Access Compliance Report

Public Rights-of-Way

(Curb Ramps)

Intersection ID: 5567	Main Street: JOHN_KIRK_DR	Cross Street: UNIVERSITY_TERRACE_DR	Location: NE
ADA ID: A5325588DDD6	Ramp Type: Directional1	Initial Pass/Fail: Fail	Overall Compliance: No
Codes/Mitigation Info/Possible Solution		Field Measurements/Component Compliance	
Severity Score: 1.25

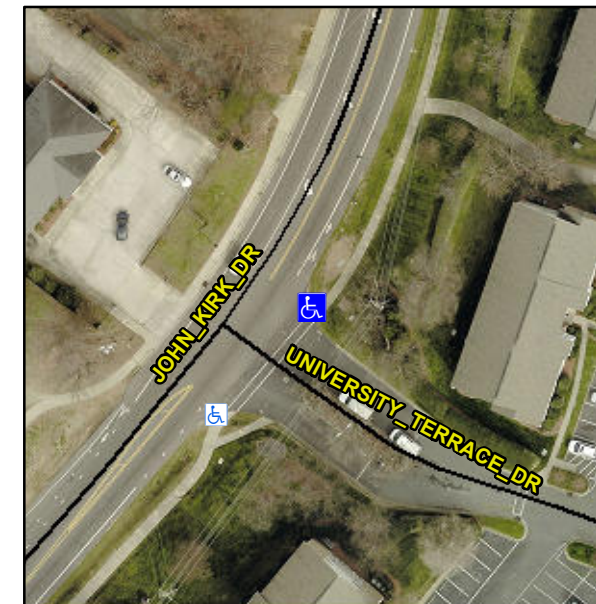
R304.5.3

Compliance	Description	Data	Compliance	Description	Data
N/A	Ramp Length (in)	58.0	N/A	Grade Break?	N/A
Yes	Ramp Width (in)	59.0	N/A	Grade Break Slope (%)	0.0
Yes	Ramp Slope (%)	2.0	N/A	Grade Break XSlope (%)	0.0
No	Ramp XSlope (%)	2.8			
N/A	Flare Type LT	N/A	N/A	Flare Type RT	N/A
N/A	Flare Slope LT (%)	N/A	N/A	Flare Slope RT (%)	0.0
N/A	Flare Traversable LT?	N/A	N/A	Flare Traversable RT?	N/A
N/A	Landing Length (in)	0.0	N/A	DWS Provided?	N/A
N/A	Landing Width (in)	0.0	N/A	DWS Contrast?	N/A
N/A	Landing Slope (%)	0.0	N/A	DWS Length (in)	N/A
N/A	Landing X Slope (%)	0.0	N/A	DWS Full Width?	N/A
N/A	Landing Curb? (Y/N)	N/A	N/A	DWS Offset LT (in)	N/A
N/A	Shared Landing?	N/A	N/A	DWS Offset RT (in)	N/A
N/A	Gutter Ponding?	0.0	N/A	Gutter Slope (%)	N/A
N/A	Gutter Lip Ht (in)	0.0	N/A	Gutter X Slope (%)	N/A
N/A	Painted X Walk1?	No		Road Slope (%)	0.1
	X Walk 1 Direction	To SW		Road X Slope (%)	2.4
	X Walk 1 Width (in)	N/A		Clear Space?	N/A

Remove & Replace Entire Ramp.
